DATE: MAY 27, 2022

TO: Chairwoman Nicole Love Hendrickson, Gwinnett County
ATTN TO: Catherine Long, Long Range Planning Manager, Gwinnett
FROM: Mike Alexander, Director, ARC Center for Livable Communities
RE: Development of Regional Impact (DRI) Review

Name of Proposal: Mixed Use Development at Satellite Boulevard

DRI #3650

G1

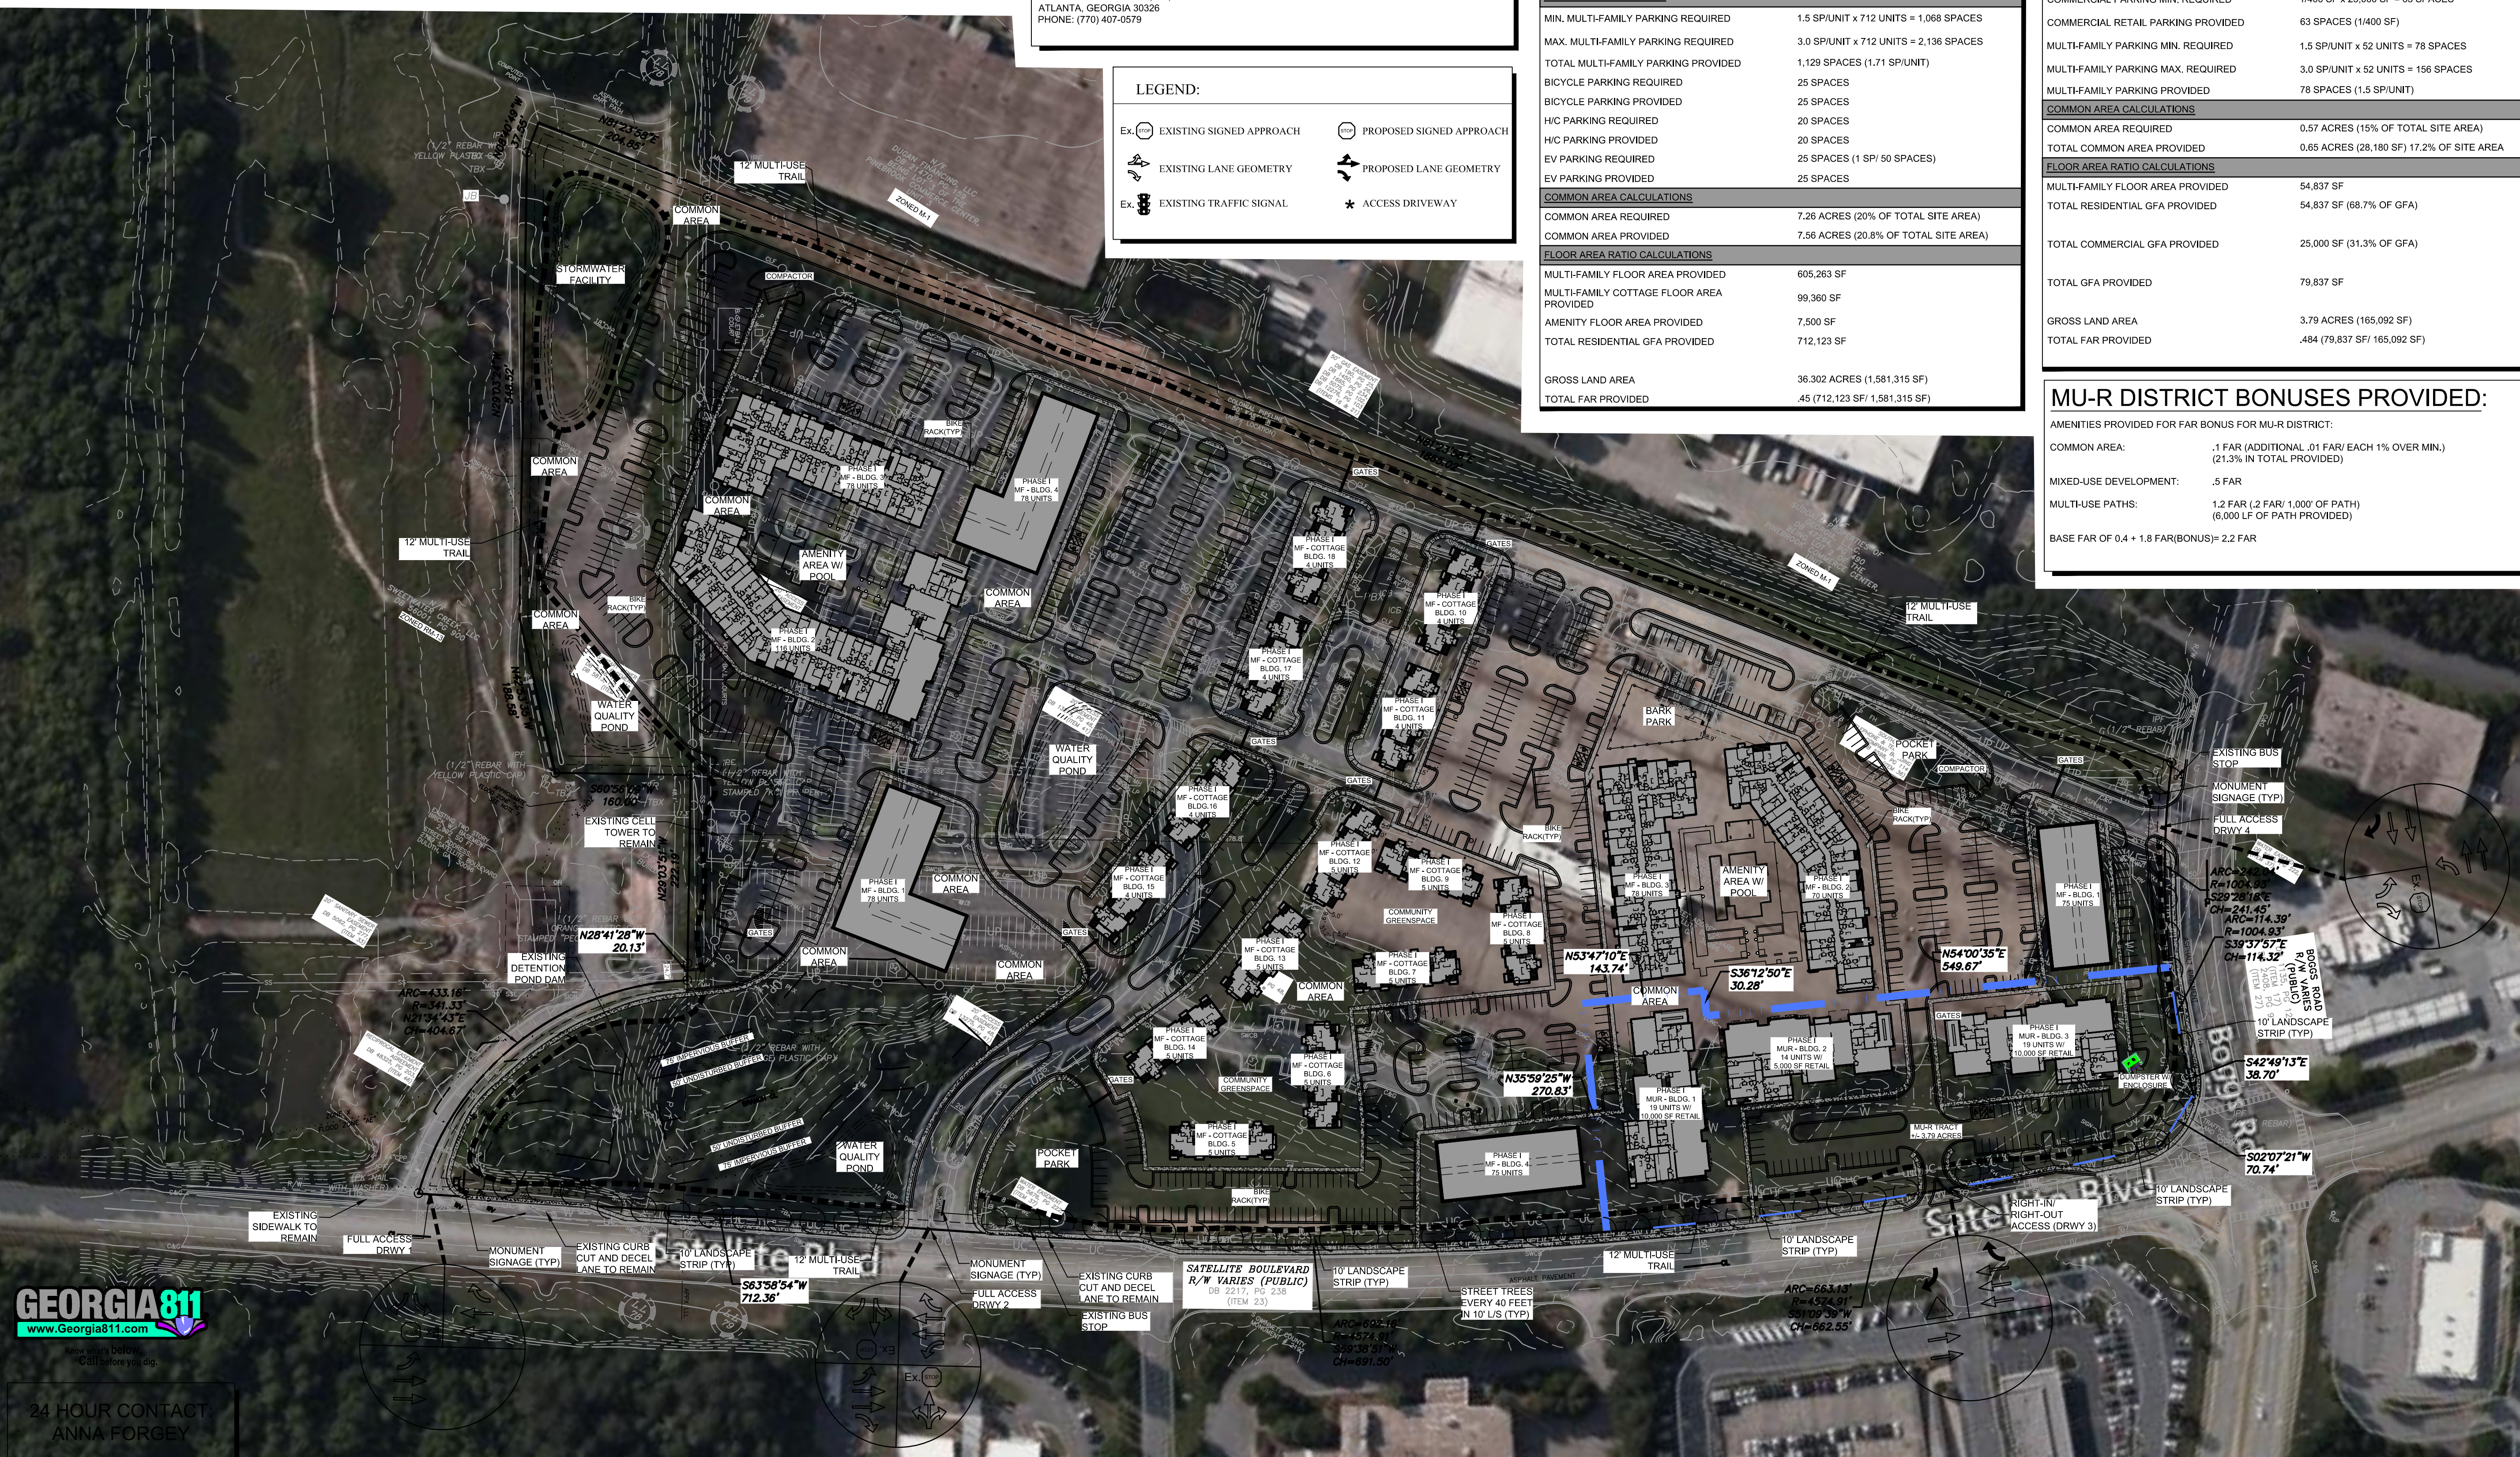
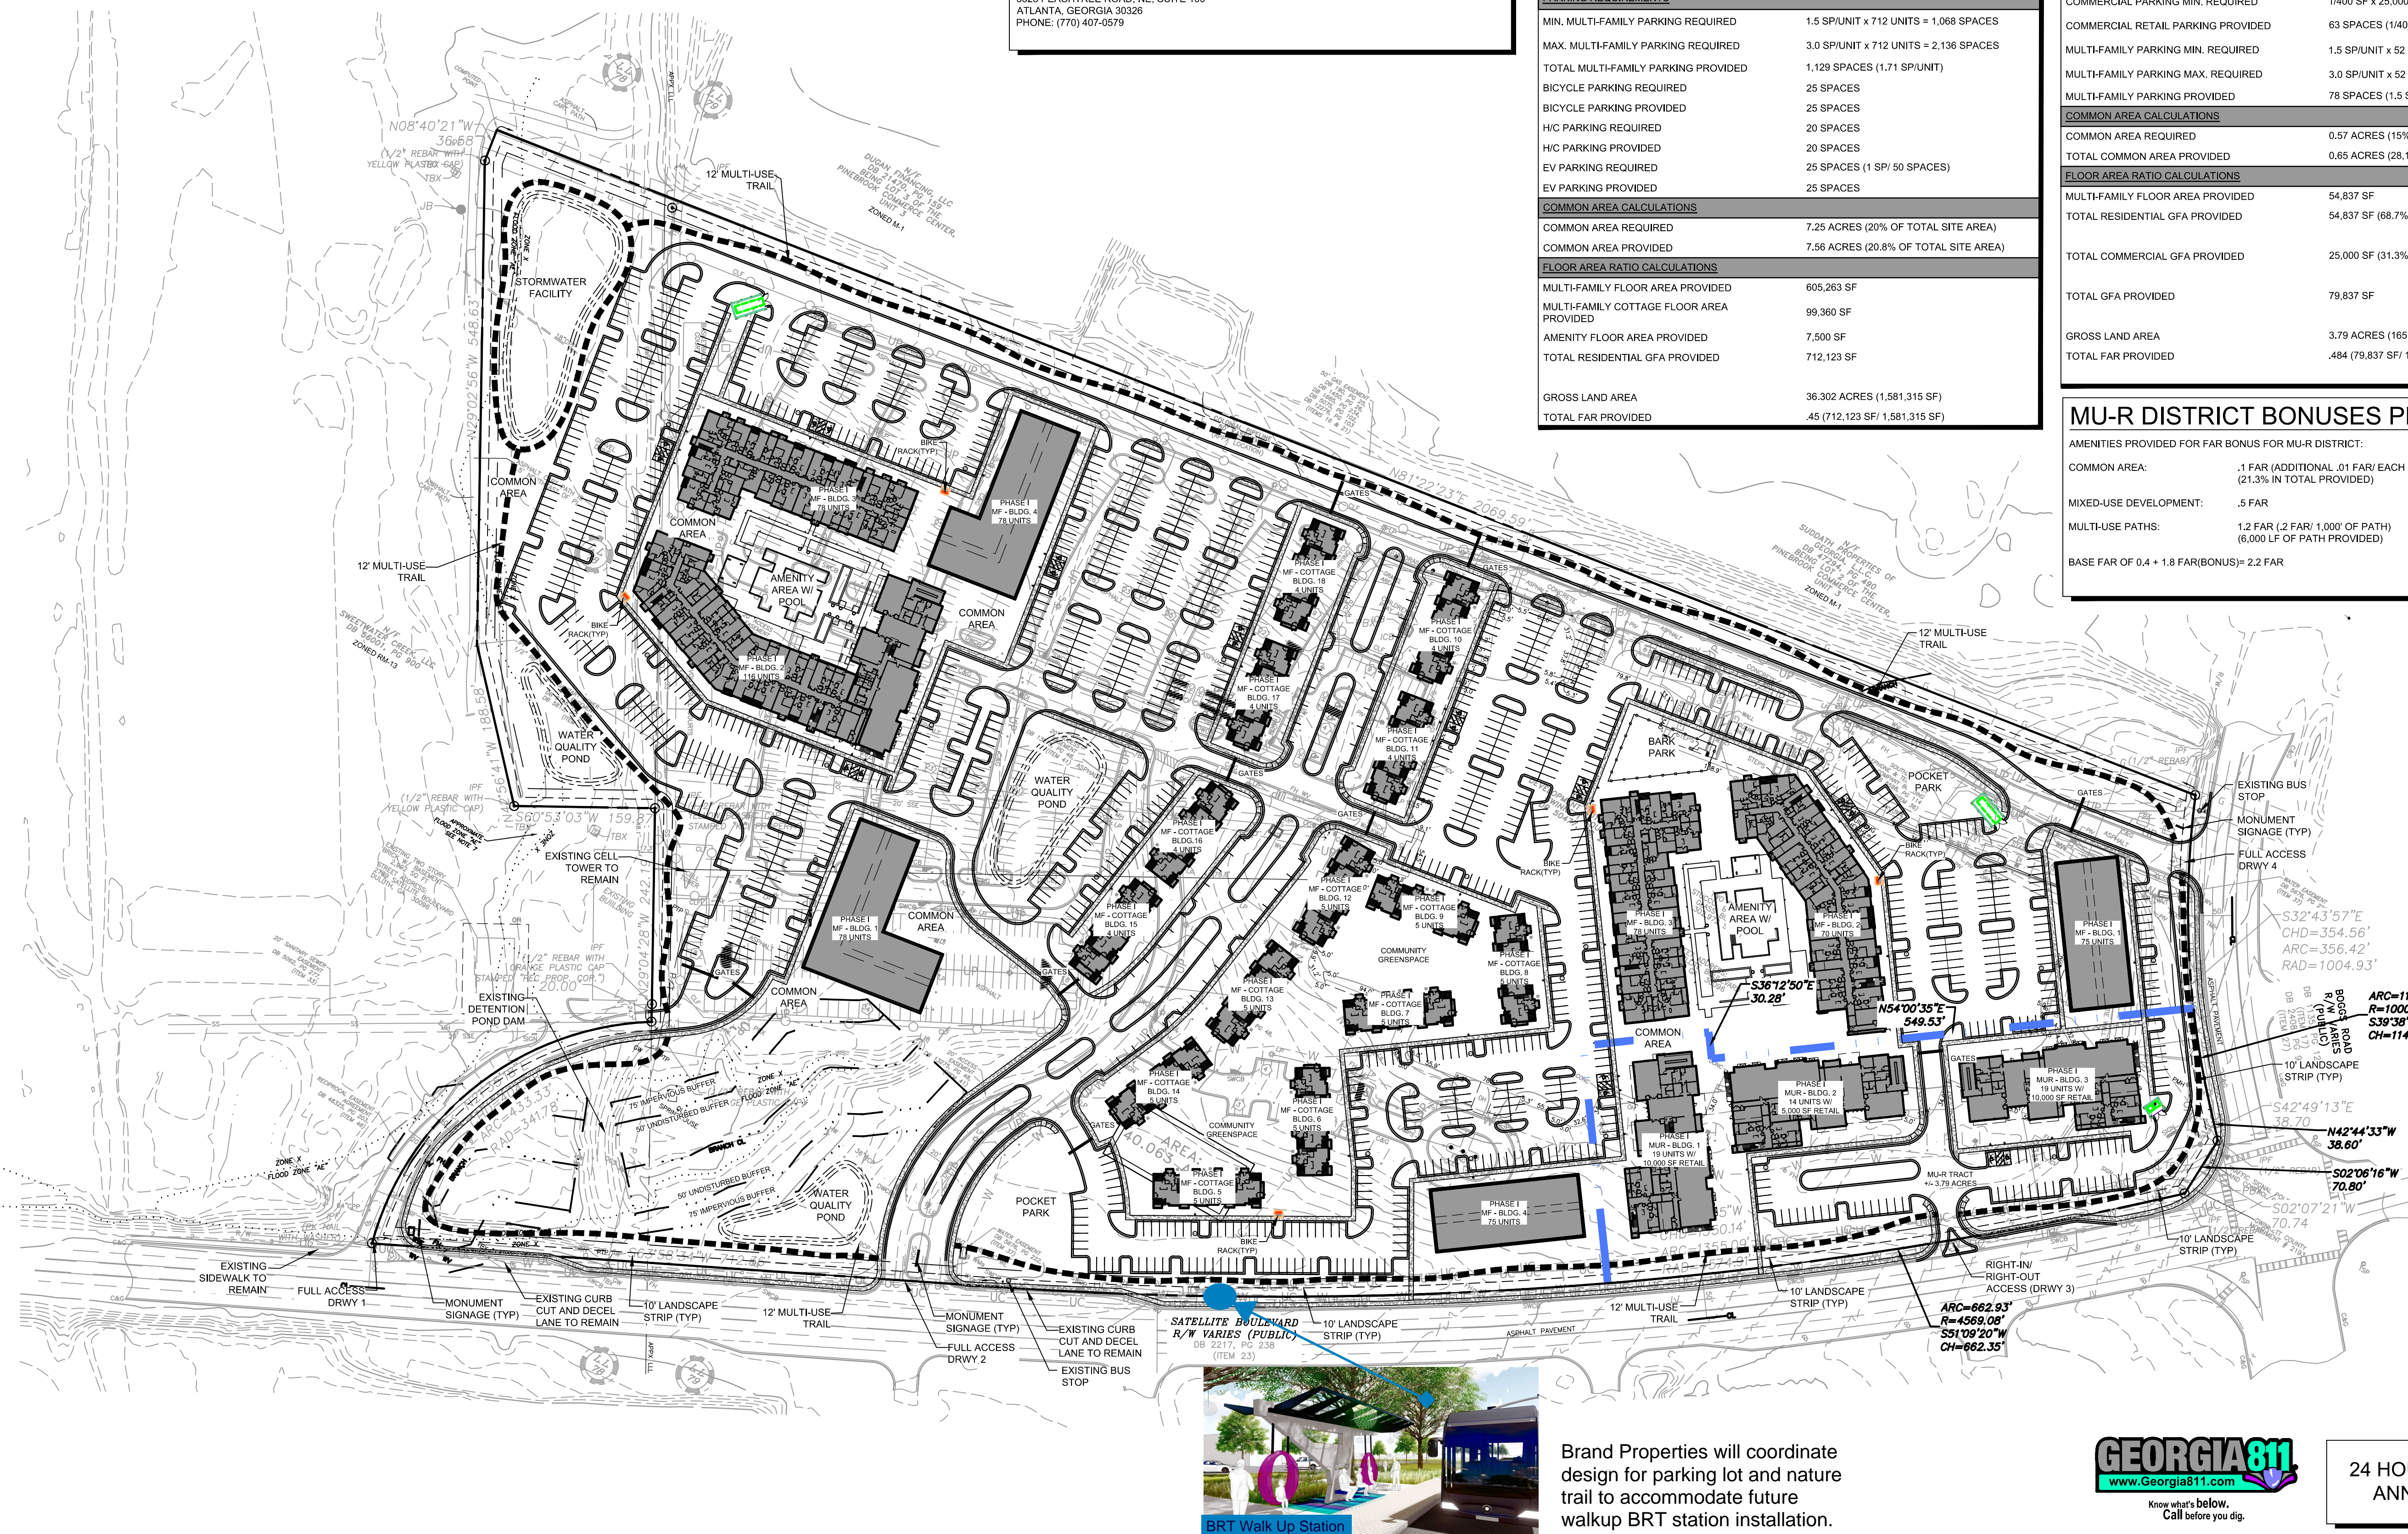
Some adjustments to the building, park, stormwater pond and multi-use trail layout could achieve better outcomes regarding placemaking and park access goals.

Adjustment of the route of the multi-use trail in the SE corner of the project to avoid safety conflicts with the active retail/restaurant area driveway and the busy intersection of Boggs Road and Satellite Boulevard could provide a safer and more enjoyable user experience while activating restaurant frontage along the trail.

The project includes approximately 712 multi-family residential units along with 25,000 SF of retail and commercial uses. Adjustment of the design of the southeastern section to achieve more building street frontage at the important corner of Boggs Road and Satellite Boulevard while maintain parking visible from the street would enhance regional placemaking goals. Some additional adjustment of the overall layout to provide more direct access from buildings to the two proposed pocket parks and central common area could help increase park usage by residents. The central stormwater pond offers the ability to serve as more of an community central focal point rather than simply a functional stormwater system element. Provision of some common courtyard or green space area adjacent to the anticipated restaurant and retail space would enhance those uses as well.

The proposed 12-foot multi-use trail around the project is very supportive of regional policies promoting safe dedicated routes for both recreational and transportation related pedestrian and bicycle trips. Ideally the trail design will be aligned with any planned or future external trail connections. A potential alternate route of the segment of the trail at the southeast corner of the project that avoids the busy intersection corner and the very active retail/restaurant driveway would provder a safer and less congested trail experience for usersl it could also activate the retail and restaurant uses fronting the trail as has been accomplished with other regional trails. as activation of food and beverage spaces.

The project includes the provision of space for a future BRT station along Satellite Boulevard. Adjusting the location of the stop towards the denser and more mixed-use southeast corner area may be a consideration. Care should be taken to ensure that the development, as constructed, promotes an interconnected, functional, clearly marked and comfortable pedestrian experience on all streets, paths, entrances, and parking areas. To the maximum extent possible, new driveways and intersection corners where pedestrians will cross should be constructed with minimal curb radii to reduce speeds of turning vehicles and decrease crossing distances for pedestrians.

The site plan shows the County 50-foot stream buffer and 75-foot impervious setback along the visible portion of the stream, with a break where an existing detention pond dam crosses the stream. The State 25-foot Sediment and Erosion Control buffer is not shown on the plans. An access road crosses the stream at the edge of the property and a portion of a parking area is shown extending into a portion of the 75-foot County buffer. The parking area, as well as any other proposed intrusions into the buffers, may require a variance from the County. The State 25-foot Sediment and Erosion Control buffer needs to be shown. Any unmapped streams on the property may be subject to the County and State buffers. Any unmapped waters of the state will also be subject to the State 25-foot Sediment and Erosion Control buffer.

There is a substantial wooded area at the southwest corner of the project in between Driveway 1 and 2 where a stormwater pond is proposed; adjusting this pond to maximize tree retention would be further supportive of tree canopy and heat island reduction goals.
